NUREG-1762
Revision 1

Integrated Issue Resolution Status Report

U.S. Nuclear Regulatory Commission
Office of Nuclear Material Safety and Safeguards
Washington, DC 20555-0001

Figure 4.1.3-1. Portions of Nevada Test and Training Range (NTTR), Federal Airways, Military Training Routes (MTRs), and Low-Altitude Training Navigation Area (LATNs)
(Adopted from Bechtel SAIC Company, LLC, 2002b, Figure 16)

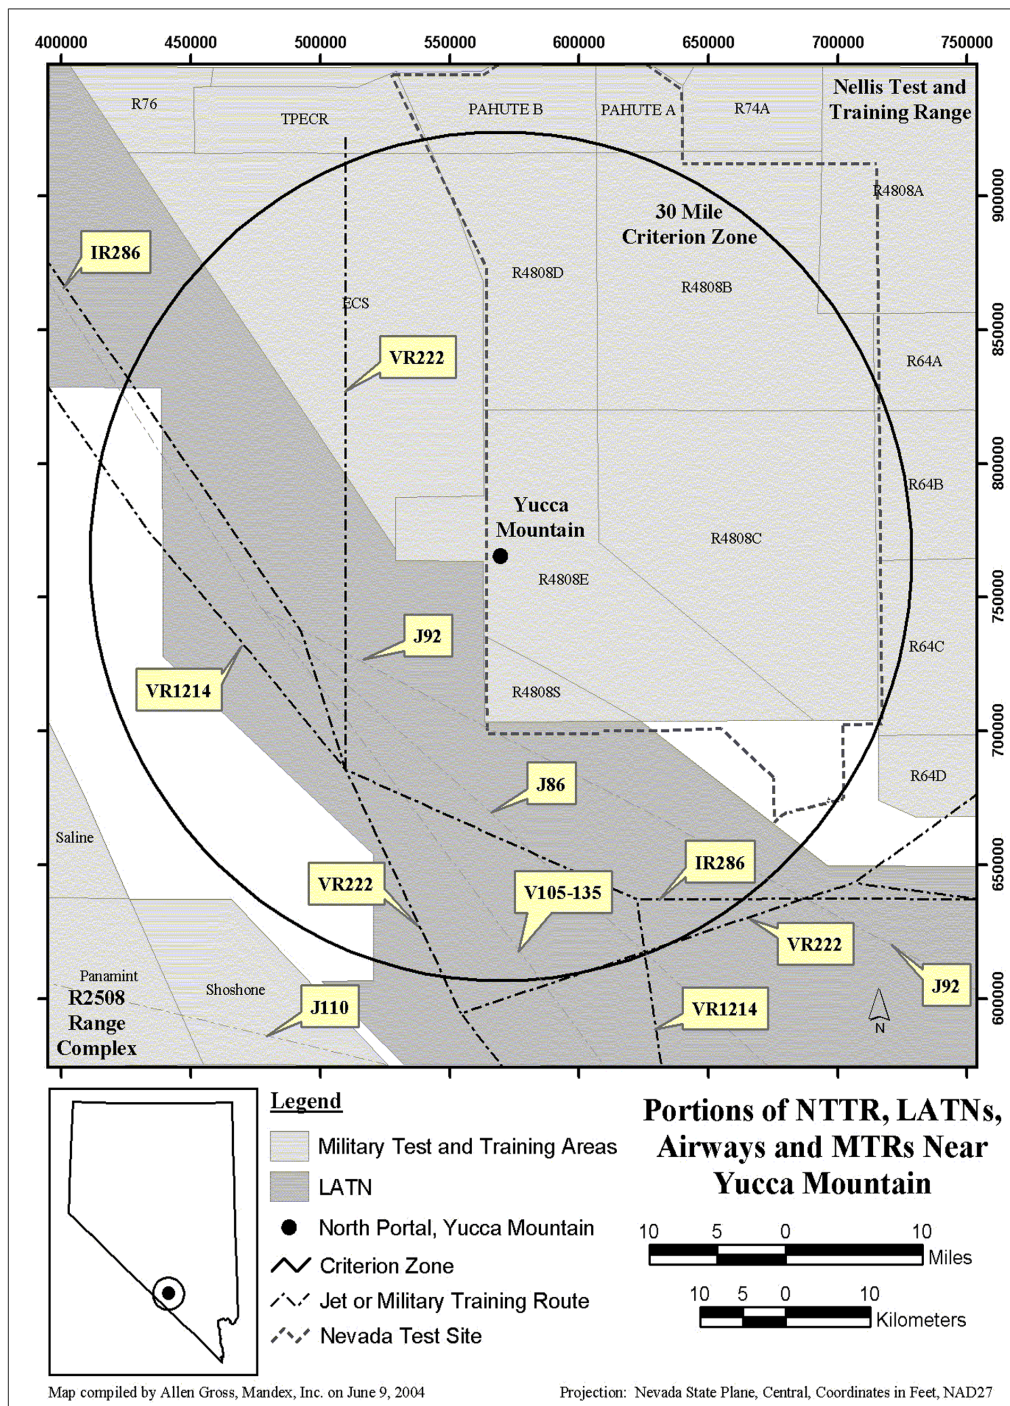
- DOE should explain the rationale for assuming the width of the aviation corridor to the southwest of Yucca Mountain to be equal to 38.4 km [24 mi] in CRWMS M&O (2003a). DOE should clarify whether this assumed width belongs to Federal airway V105-135, J86, J92, VR1214, or IR286 (Bechtel SAIC Company, LLC, 2002b, Figure 16). DOE should clarify whether the assumed width of the airway is the same as used by the Federal Aviation Administration, as discussed previously.
